A&M Project #: 1843-04A
Re: 33 and 39 Main Street
Map 41, Lot 35 and 35-0001
Insubstantial Change Request
Under 760 CMR 56.05(11)

Allen & Major Associates, Inc. (A&M), on behalf of Medway Residential LP (a.k.a. Hathon), has prepared this letter in connection with the above-referenced Comprehensive Permit for 33 and 39 Main Street. As outlined in 760 CMR 56.05(11), we are requesting review by the Board to determine whether the following change is deemed substantial or insubstantial as defined under 760 CMR 56.07(4).

Exhibit A

Original ZBA Comprehensive Permit drawings by Legacy Engineering

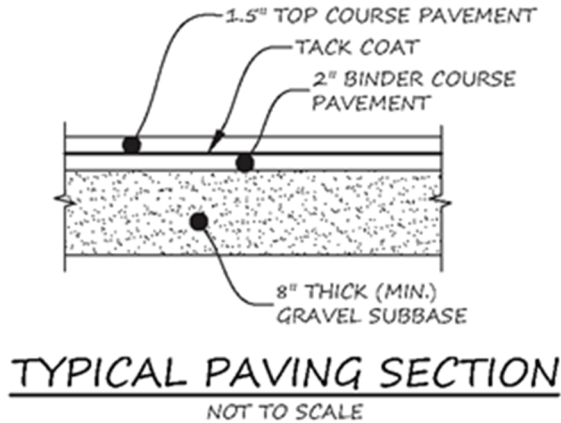
The first two images on the following pages show the pavement section details that the Board has previously reviewed and approved. The third detail has a Note #3 that references the removal of the heavy duty pavement, for which we are requesting approval as an insubstantial change. We thank you in advance for your consideration.

Requested "Insubstantial Change" pavement detail:

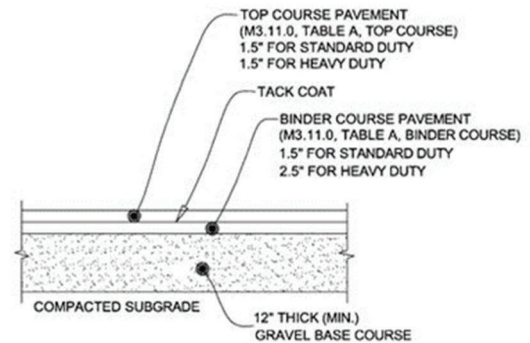
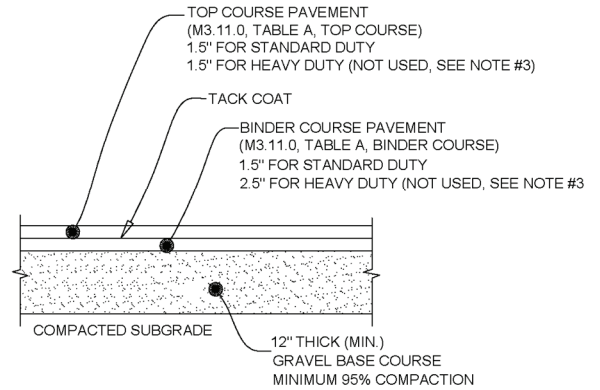
Medway Residential, LP respectfully requests that the “standard duty” pavement section be used throughout the site and the “heavy duty” pavement section proposed for the drive aisles be eliminated. In reviewing 760 CMR 56.07(4) we suggest that the proposed change does qualify as “insubstantial”. Although we may meet the statutory definition of “insubstantial”, we understand that the Board is also concerned with having a well-built project that will last. In support of the request, we offer the following:

- The project is using a 12” gravel base course, whereas an 8” gravel base course was originally approved.
- The field density testing has typically exceeded the minimum 95% dry density requirement.

Medway Residential, LP does acknowledge that the life cycle of the pavement may be reduced by eliminating the heavy duty pavement; however, any eventual repairs or maintenance would be borne by the owner of the property and could be mitigated with maintenance measures such as seal coating and crack filling.

3. THE DEVELOPER (TOLL BROTHERS APARTMENT LIVING) DECIDED TO EXCLUDE THE HEAVY DUTY PAVEMENT SECTION AS PART OF A VALUE MANAGEMENT DECISION. CONSEQUENTLY, THE STANDARD PAVEMENT SECTION WILL BE USED THROUGHOUT. THE GEOTECHNICAL ENGINEER HAS ADVISED THAT THE LIFE CYCLE OF THE PAVEMENT MAY BE REDUCED.
